# Access Compliance Report

## Public Rights-of-Way

Intersection ID: 14949	Main Street: CAMPBELL_DR	Cross Street: DRIFTWOOD_DR	Location: NE
ADA ID: AB64BF309EF5	Ramp Type: BlendTrans1	Initial Pass/Fail: Fail	Overall Compliance: No
		Severity Score: 25

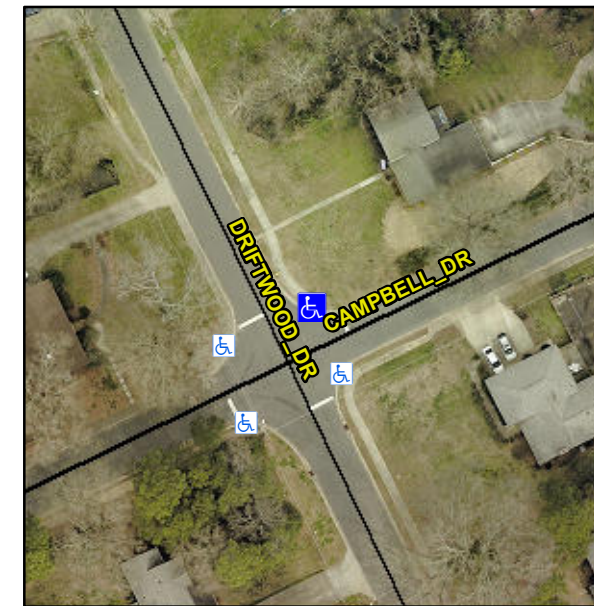
**Not Found, R304.5.3**

Compliance	Description	Data	Compliance	Description	Data
N/A	Ramp Length (in)	85.0	Yes	BlendTrans Slope (%)	4.0
Yes	Ramp Width (in)	48.0	No	BlendTrans XSlope (%)	10.7
N/A	Flare Type LT	N/A	N/A	Flare Type RT	N/A
N/A	Flare Slope LT (%)	N/A	N/A	Flare Slope RT (%)	N/A
N/A	Flare Traversable LT?	N/A	N/A	Flare Traversable RT?	N/A
N/A	Landing Length (in)	N/A	N/A	DWS Provided?	N/A
N/A	Landing Width (in)	N/A	N/A	DWS Contrast?	N/A
N/A	Landing Slope (%)	N/A	N/A	DWS Length (in)	N/A
N/A	Landing X Slope (%)	N/A	N/A	DWS Full Width?	N/A
N/A	Landing Curb? (Y/N)	N/A	N/A	DWS Offset (in)	N/A
N/A	Shared Landing?	N/A			
N/A	Gutter Ponding?	N/A	N/A	Gutter Slope (%)	N/A
N/A	Gutter Lip Ht (in)	N/A	N/A	Gutter X Slope (%)	N/A
N/A	Painted X Walk1?	No	N/A	Painted X Walk2?	No
	X Walk 1 Direction	To SW		X Walk 2 Direction	To SE
	X Walk 1 Width (in)	N/A		X Walk 2 Width (in)	N/A
	X Walk 1 Slope (%)	2.3		X Walk 2 Slope (%)	8.8
	X Walk 1 X Slope (%)	11.2		X Walk 2 X Slope (%)	0.6

**Remove & Replace Curb Ramp With Two New Directional Ramps or Equivalent.**
